FirstEnergy Nuclear Operating Company

September 25, 2014
L-14-285

Perry Nuclear Power Plant
Docket No. 50-440, License No. NPF-58
FirstEnergy Nuclear Operating Company's (FENOC's) Revision of Overall Integrated Plan for Perry Nuclear Power Plant in Response to March 12, 2012 Commission Order Modifying Licenses with Regard to Requirements for Mitigation Strategies for Beyond-Design-Basis External Events (Order Number EA-12-049) (TAC No. MF0962)

Overall Integrated Plan for Perry Nuclear Power Plant, Revision 1

Figure A3-1: RCIC Alternate Suction Connection Point (el. 568' Auxiliary Building)

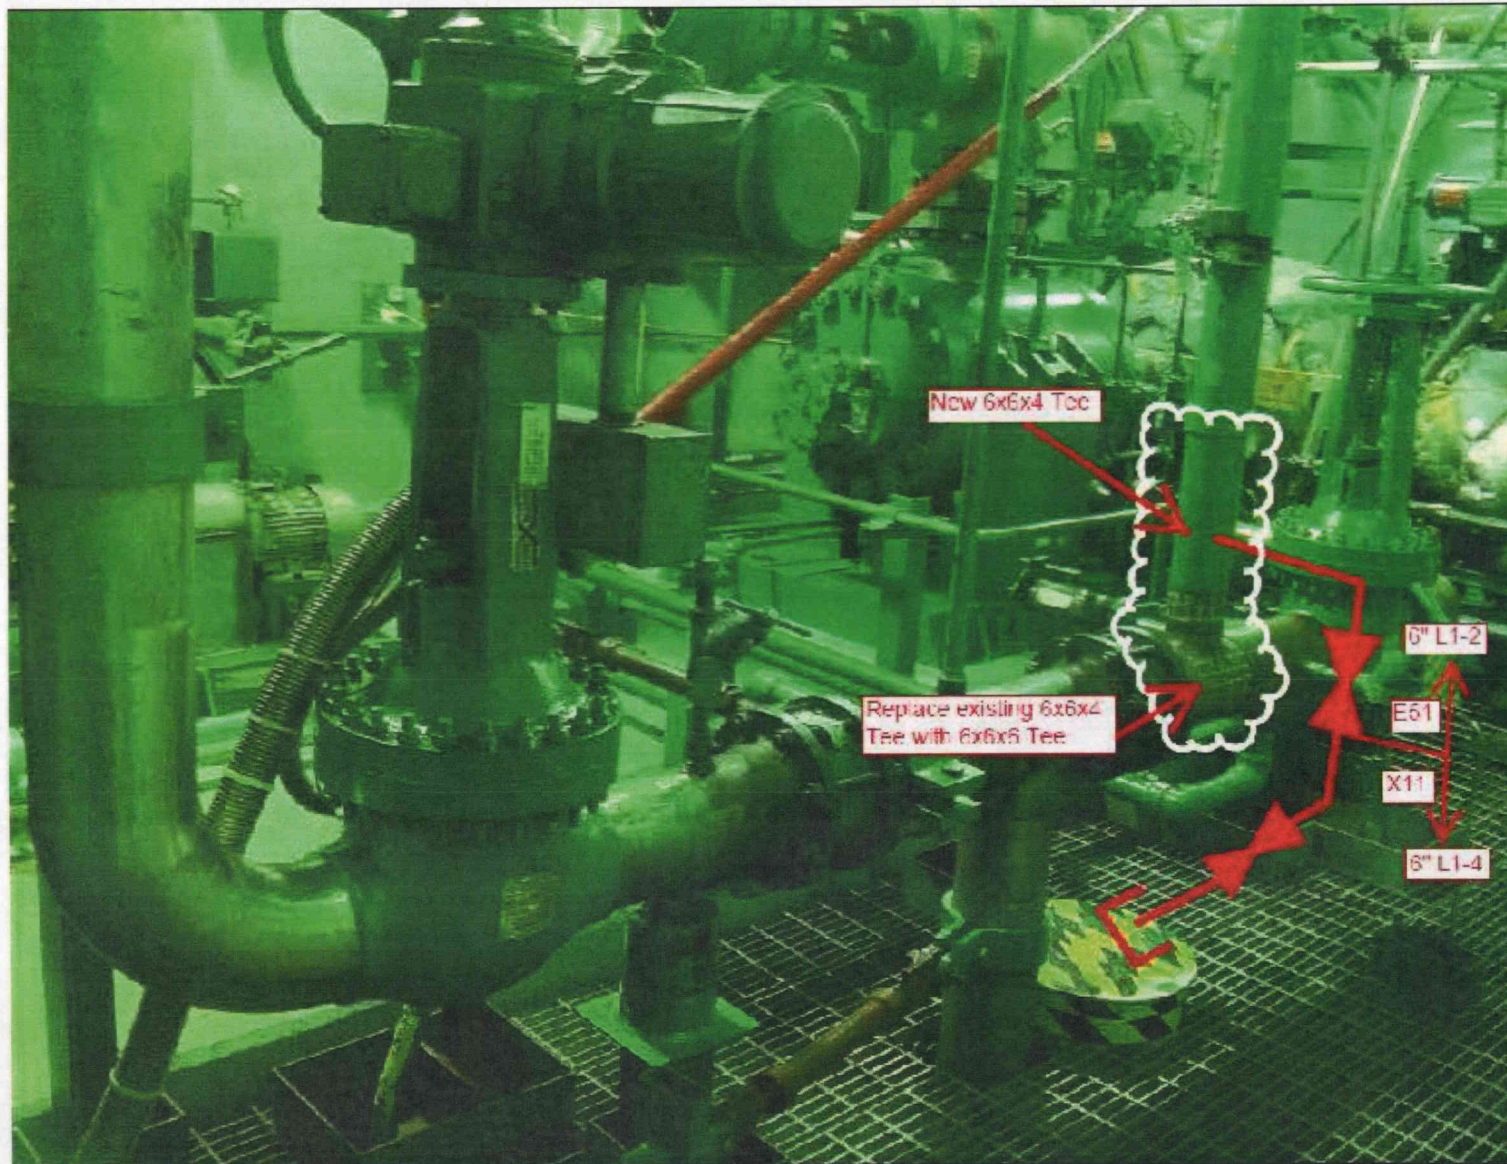
| Maintain Core Cooling & Heat Removal | |
|---|---|
| Identify modifications | <ul style="list-style-type: none"> • Install six inch isolation valve(s) and Storz hose connection on the RCIC pump suction pipe (Figure A3-1) • Install Pipe connections on ESW A and ESW B pipes in ESWPH • Install Storz hose connections on ESW A and ESW B pipes in Auxiliary Building (Figures A3-2, A3-3) • Install hose connections on Demin Water Source Tanks <ul style="list-style-type: none"> ○ Two Bed Storage Tank ○ Mixed Bed Storage Tank • Modify LPCS Flange to install 5" Storz Connection (Figure A3-7) |

Figure A3-10: ADHR Piping Modification Location (302-0246)

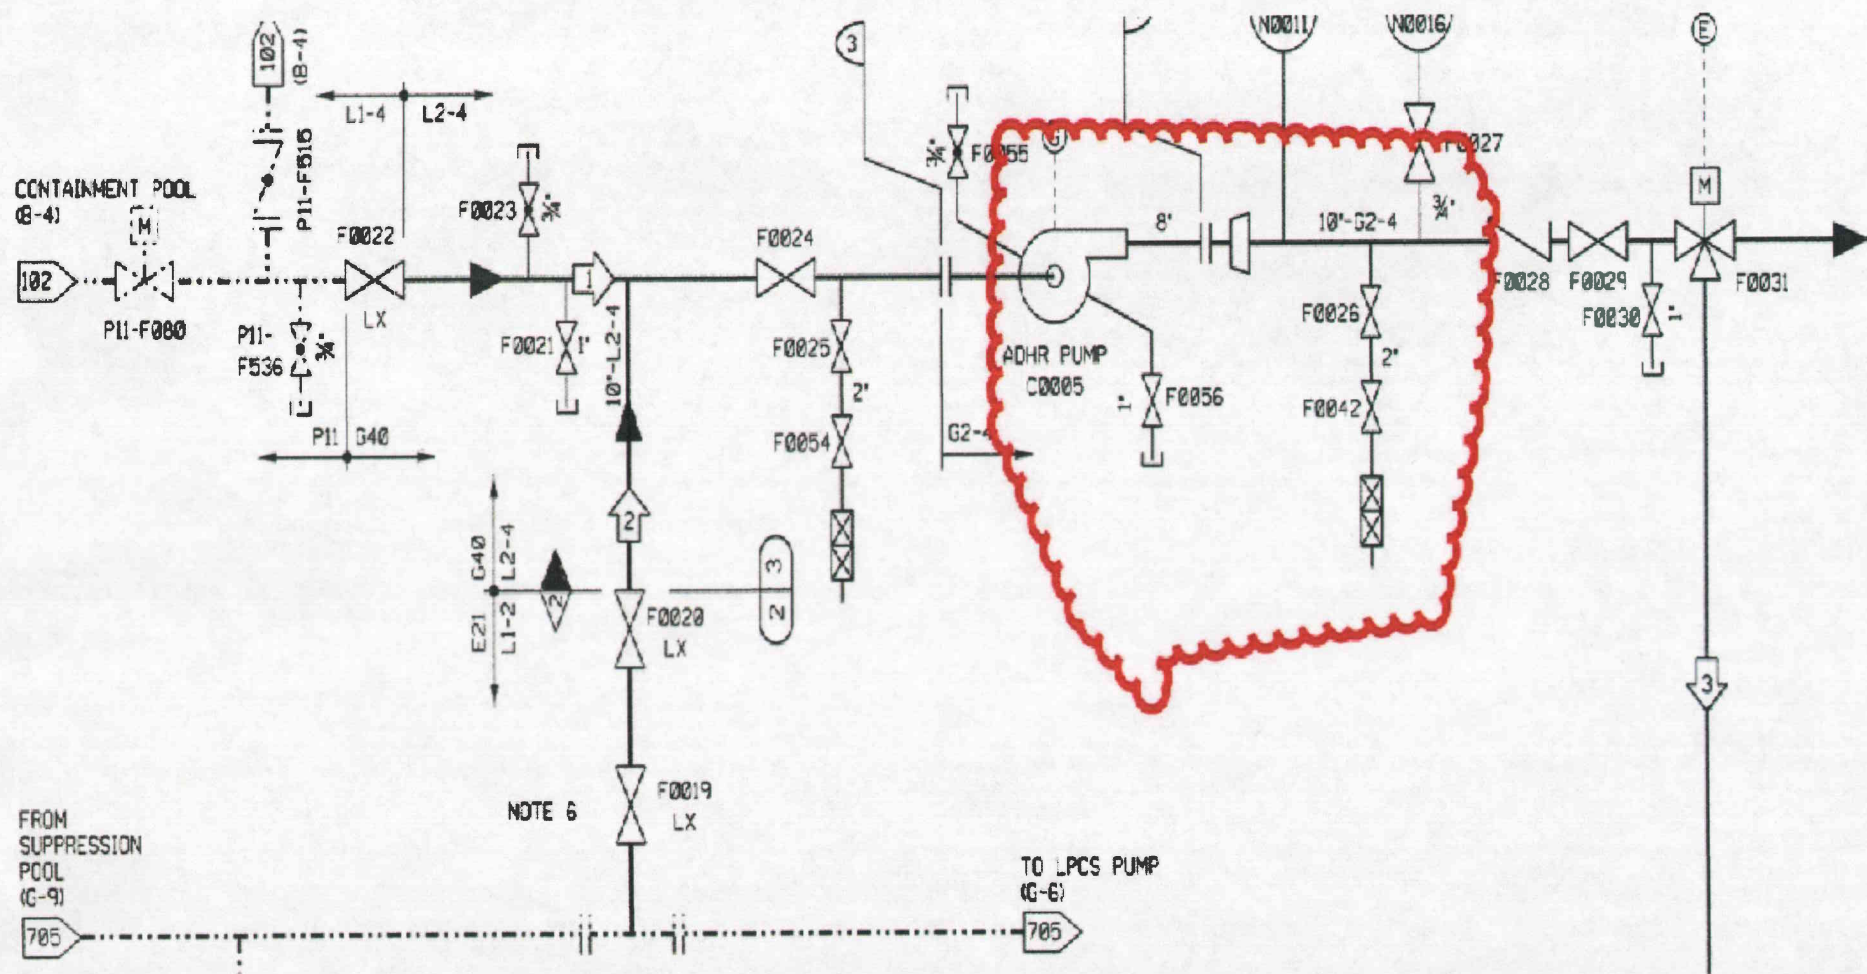
| Maintain Containment | |
|--|---|
| <p>be installed seismically. See Figure A3-10, ADHR Piping Modification Location for details of the modification.</p> <p>Mode 5 / Refueling</p> <p>Containment function will not normally be challenged during the event due to containment integrity being relaxed and the containment open during Mode 5 / Refueling.</p> <p>There may be brief periods during Mode 5 / Refueling when containment integrity might be required, such as during an operation with a potential to drain the reactor vessel. If a BDBEE occurred during these times the containment function would not be challenged based on containment response analysis performed for Modes 1 through 4 which uses cases bounding for Mode 5 due to the decrease in decay heat rate.</p> <p>Containment Hydrogen Control</p> <p>The PNPP Mark III containment atmosphere is not inerted and contains free oxygen during normal operation. An event that overheats the fuel can generate free hydrogen gas that could cause a violent hydrogen/oxygen reaction when within certain concentration ranges in the presence of an ignition source. To preclude damage to equipment inside the Containment, hydrogen igniters are energized to stimulate early, non-violent reactions of hydrogen and oxygen at low hydrogen concentrations outside the explosive ranges.</p> <p>During the postulated FLEX event and response, no fuel damage will occur but NEI 12-06 requires consideration of hydrogen control during FLEX events.</p> <p><u>Primary Method</u></p> <p>Installed Division 1 hydrogen igniters would be repowered to suppress hydrogen buildup in case of zirconium/water reaction from an overheated core. Normal power sources are from the Division I vital 480 Vac bus. Either division is adequate for control of hydrogen. With the onsite FLEX generator(s) connected in Phase 2, the current draw from the igniters is considered in the FLEX generator load assessment (Reference 9). Current plant procedures would be used for initiating hydrogen igniter operation. Portable small generators are also available for local 120 Vac operation of the igniters.</p> <p><u>Secondary Method</u></p> <p>Division 2 hydrogen igniters are also adequate for control hydrogen concentrations. Like Division 1, these are powered from the 480 Vac vital bus but small portable generators are available for backup use.</p> | |

Figure A3-11: SFP Fill Header Routing

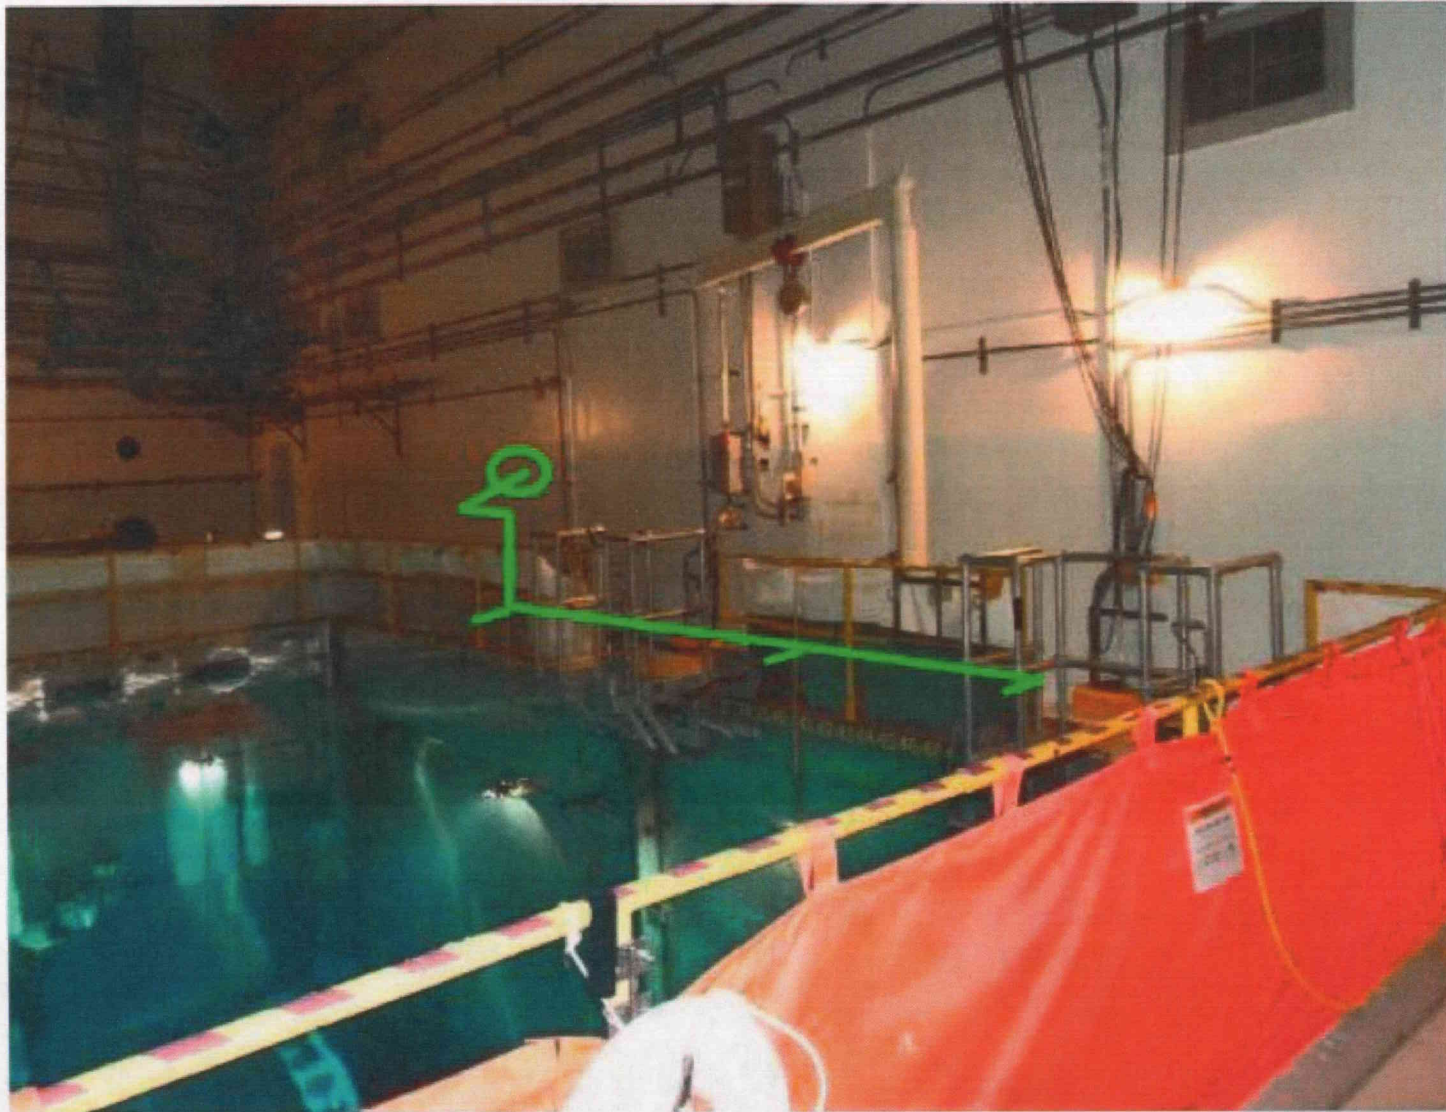
| Maintain Spent Fuel Pool Cooling | |
|--|--|
| Identify modifications | <p><i>List modifications and describe how they support coping time.</i></p> <p>Construct a SFP makeup header supplied by ESW A and ESW B (Figure A3-11).</p> |

Figure A3-18: Main FLEX Storage, Staging, and Access

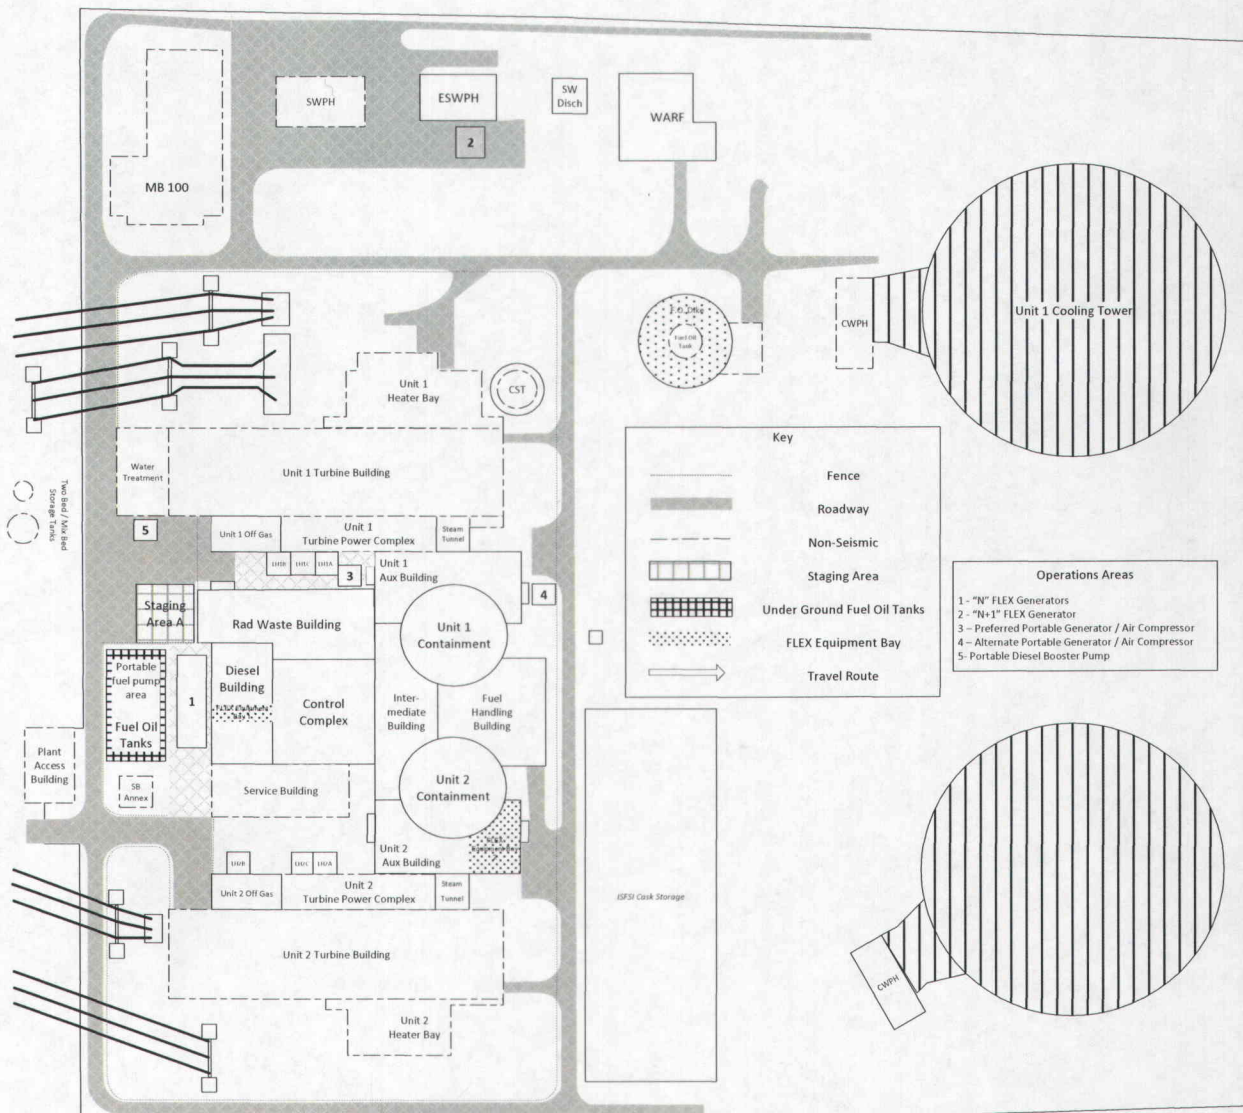
| Maintain Containment | | |
|---|---|---|
| Hoses and other equipment required in the Unit 1 Aux Building will be deployed the short distance between the Unit 1 and FLEX Equipment Bay 2 (Unit 2 Auxiliary Building) (Figure A3-18) or will be stored in the Unit 1 Aux Building. | | |
